Change of Cover Plate to LLFS 90

2. Technical Change

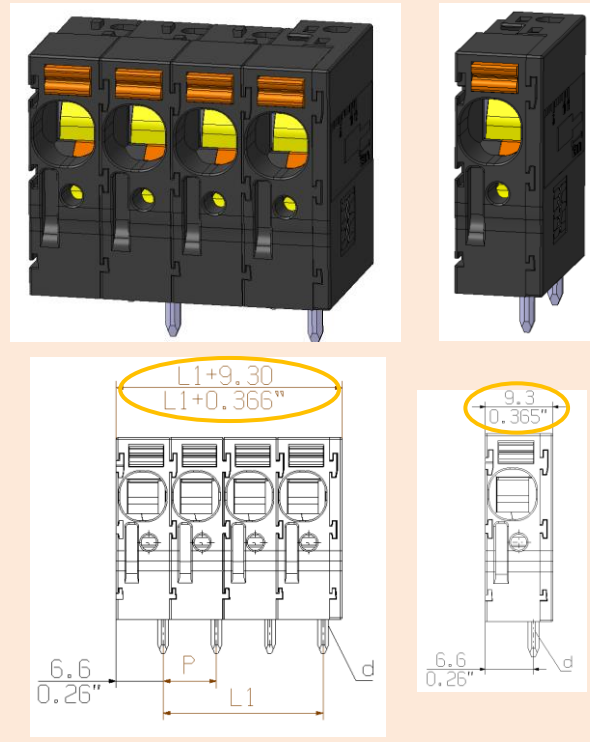
The geometry of cover plate will be changed to LLFS 90° version.

LLFS 90 Old design

LLFS 90 New design

The cover plate of the outside pole position has been improved to be more stable while bending biggest connected solid wires.

The overall dimension has increased as shown in section 2. There is no influence on electrical data in the data sheet.
